MINUTES OF THE REGULAR MEETING OF THE PLAN COMMISSION, VILLAGE OF TINLEY PARK, COOK AND WILL COUNTIES, ILLINOIS

June 1, 2023

ITEM #1: WORKSHOP – GAS N WASH, 18301 LAGRANGE RD – SPECIAL USE, FINAL PLAT, VARIATIONS, AND SITE PLAN/ARCHITECTURAL APPROVAL

PLAN COMMISSION STAFF REPORT

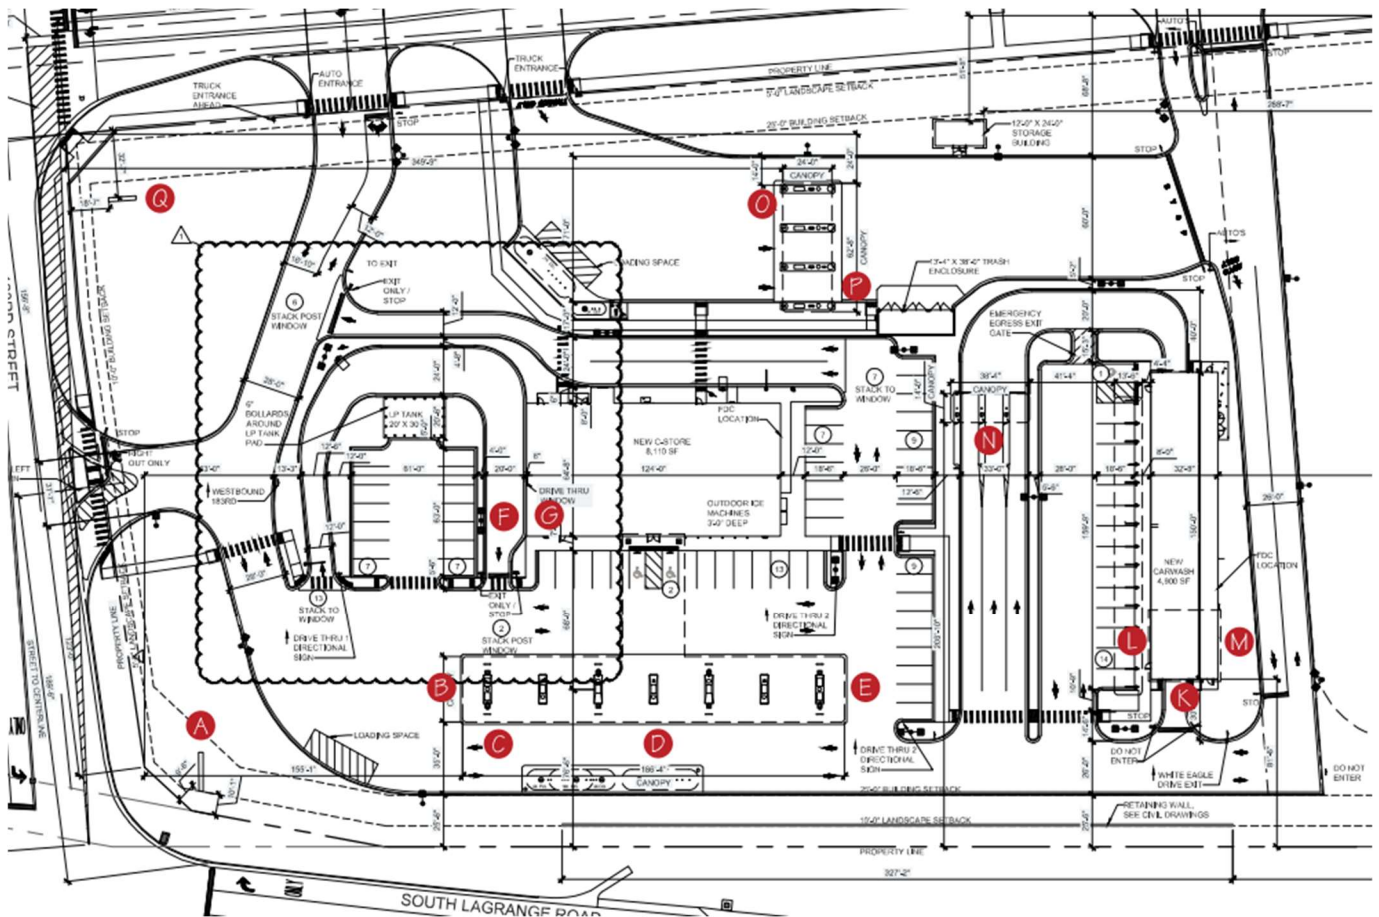
There is a trash enclosure and a storage building located in front of the building along White Eagle Drive. These structures will be designed in a manner compatible with the convenience store building. These structures must be located to the side or rear of the site (Sec. III.H.2.).

Open Item #5: Discuss the prominence of the rear/main pedestrian entrance to the building, and whether additional architectural treatments of this façade are desired and justified.
